COUNCIL ASSESSMENT REPORT

Panel Reference	PPSSEC-86
DA Number	DA321/2020/1
LGA	Woollahra Municipal Council
Proposed Development	Demolition of existing structures and construction of a shop top housing development
Street Address	19-27 Cross Street DOUBLE BAY (Lot 100 of DP 617017)
Applicant/Owner	Applicant: SDHA Pty Ltd; Owner: Tri-Anta Pty Ltd
Date of DA lodgement	28 August 2020
Total number of Submissions Number of Unique Objections	Seven
Recommendation	Refusal
Regional Development Criteria (Schedule 7 of the SEPP (State and Regional Development) 2011	Development that has a capital investment value of more than \$30 million (CIV \$40,434,422)
List of all relevant s4.15(1)(a) matters	<ul style="list-style-type: none"> • List all of the relevant environmental planning instruments: s4.15(1)(a)(i) <ul style="list-style-type: none"> - State Environmental Planning Policy 65: Design Quality Of Residential Flat Development inclusive of Apartment Design Guide - State Environmental Planning Policy (Building Sustainability Index: BASIX) 2004; - State Environmental Planning Policy (Infrastructure) 2007; - State Environmental Planning Policy 55: Remediation Of Land; - State Environmental Plan

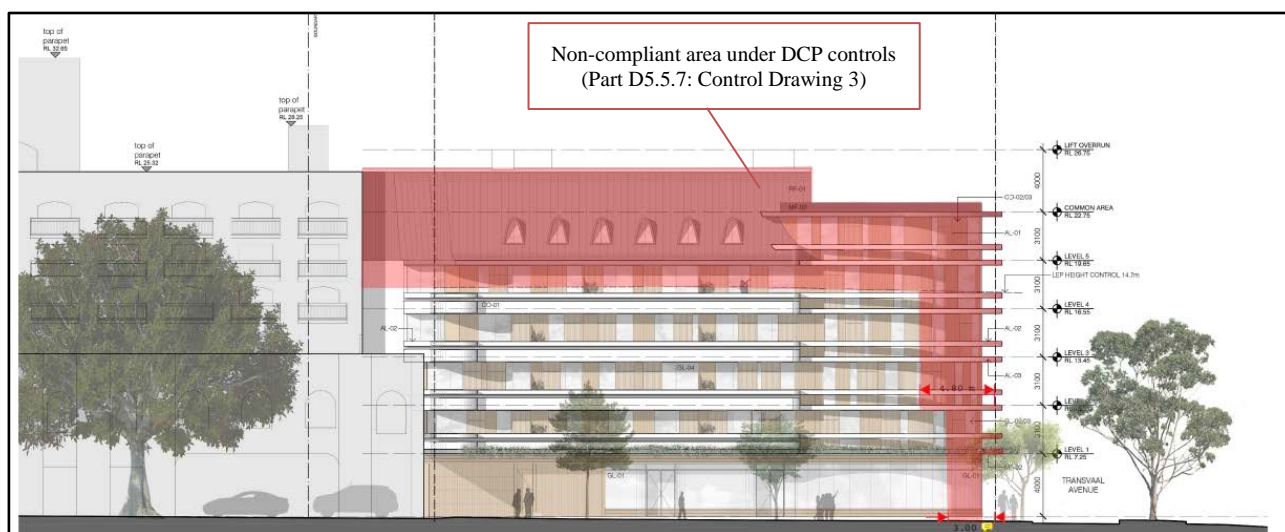
As discussed above, the proposal does not respond to the evolving character, particularly with respect to the street wall height and setbacks.

The proposal has relied on the corner character of the subject site to maximise its proposed density. However, it is not identified as a significant corner site in WLEP 2014 or WDCP 2015. Additionally, the proximity to the HCA is of higher importance than the relationship to the street corner. In my opinion, the proposed built form does not provide a suitable transition to the HCA.

I recommend that the proposed bulk and scale be amended to respond to my comments above."

Proposed Elevation - South (Source: Luigi Rosselli Architects; Overlay: Woollahra Council)

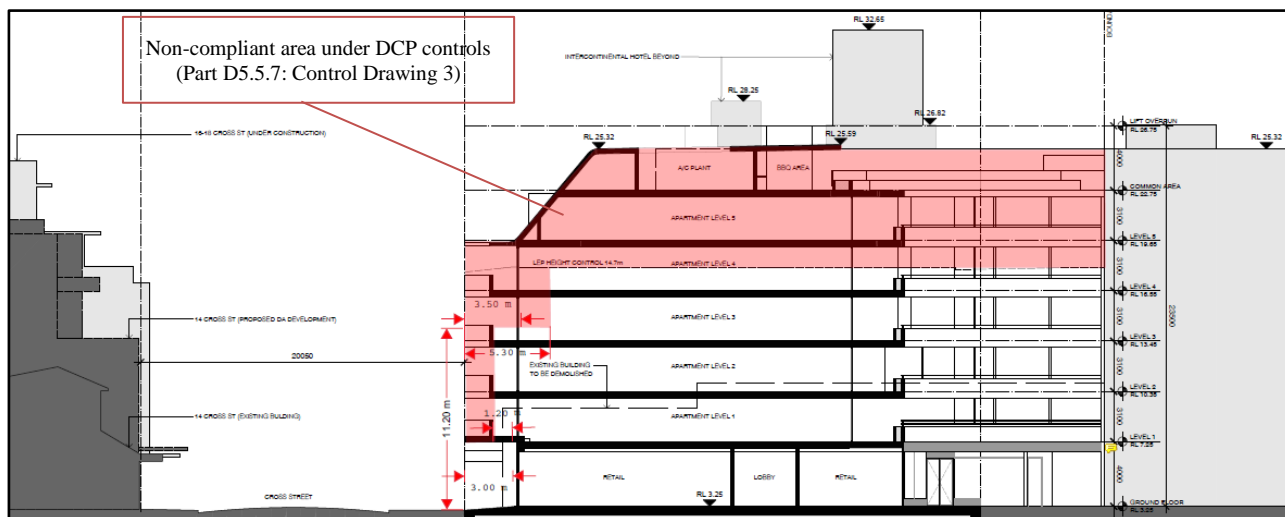
- The WDCP (in *Section D5.4: Street Character* and *Section D5.5.7 Control Drawing 3*) prescribes the desired future street character for the 'Cross Street' precinct. Refer to **Elevations, Sections** and **Extracts** below comparing the proposed development against the prescribed building envelope controls of the DCP for the subject site;

- On the northern side of Cross street, there is an existing established two-storey street wall height at the Intercontinental Hotel;

- On the southern side of Cross Street, there is an evolving four-storey street wall height (recently approved and under construction developments at 16-18, 20-26 and 28-34 Cross Street);
- It neither responds to the to the existing street wall height nor the four-storey street wall height envisaged by Woollahra DCP 2015, D5.4.7 and D5.5.7, or displayed by the recent development on the southern side of Cross Street with 4-storey street wall.
- The proposed 6-7 storey building with a proposed 6-storey street wall height and reduced front setbacks to Transvaal Avenue will result in a building that is inconsistent with the *existing character* and the *future character* of its surrounding context, given the following:
 - It neither responds to the two-storey street wall height envisaged by Part D5.5.7 nor the existing single-storey buildings of the Transvaal Avenue HCA.

Figure 13 Section AA - Red indicates area of Building Height non-compliance (Source: Luigi Rosselli Architects; Overlay: WMC)

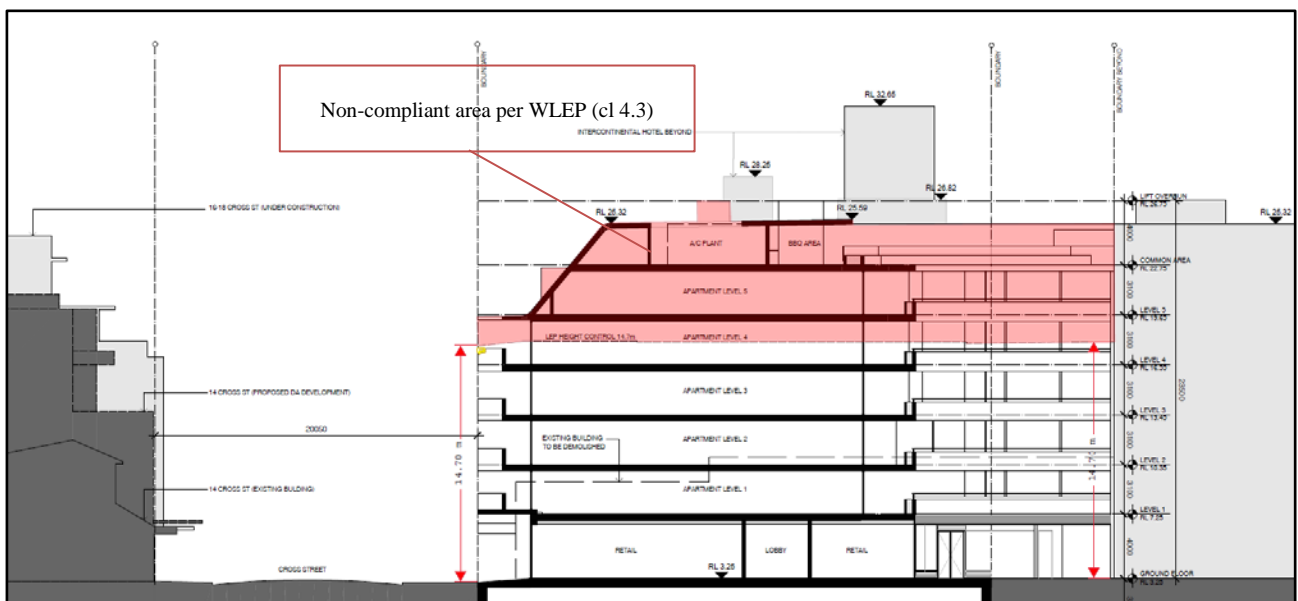
The proposal does not comply with the maximum building height prescribed by Part 4.3(2) of Woollahra LEP 2014. A Clause 4.6 written request has been submitted by the applicant and is assessed below.

Comment: The proposal does not *establish a transition in scale between zones* in that it results in a six-seven storey building which is approximately two and a half storeys over the 14.7m height of buildings standard, as required by sub-clause 4.3(b) of the WLEP in that:

- The proposed height, bulk and scale is not considered to provide an appropriate nor a sympathetic transition between the Cross Street precinct to the Transvaal Avenue HCA located immediately to the north of the site.
- The Transvaal Avenue HCA includes single-storey contributory buildings that are generally uniform in scale, form and detailing.
